Comments regarding the proposed well at Horseshoe Bend

Bighorn Canyon National Recreation Area

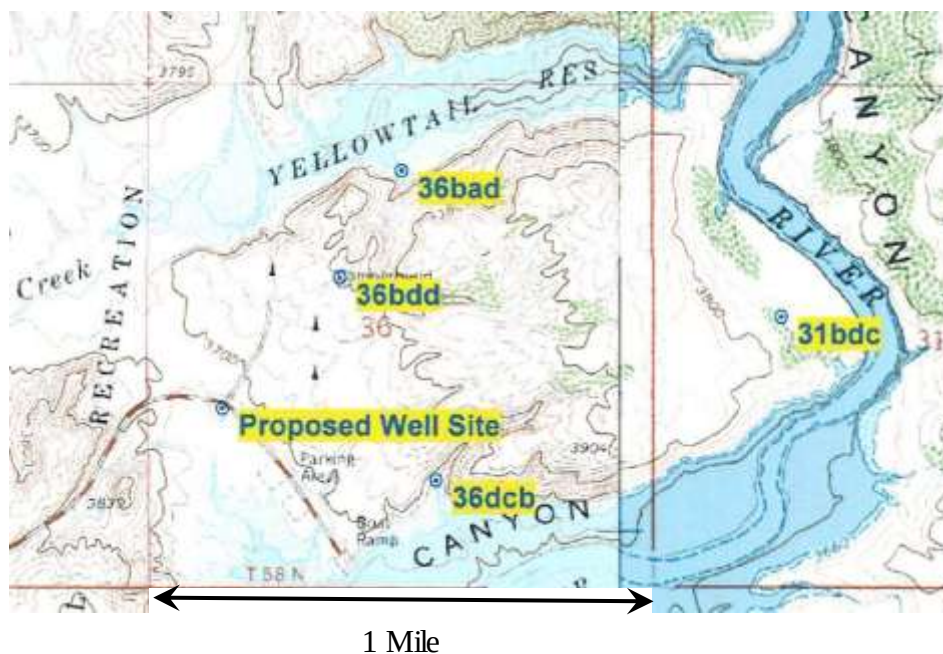
Water levels in the test holes at Horseshoe Bend were measured approximately monthly from the date that each well was completed in 1966 until late-November 1967. This coincided with the initial filling of the reservoir. Water levels in the test holes rose from about 3550 feet above mean sea level to about 3635 feet msl. I could not find any other

If we assume these data are representative of current conditions, we would expect the water level in a well constructed into the Madison Formation to rise within the well casing to about 3630-3640 feet msl. Land surface at the proposed well site is about 3680 feet. **Therefore we should expect the water level in the well to be about 40-50 feet below ground surface.** The location of the test wells are shown on this map.
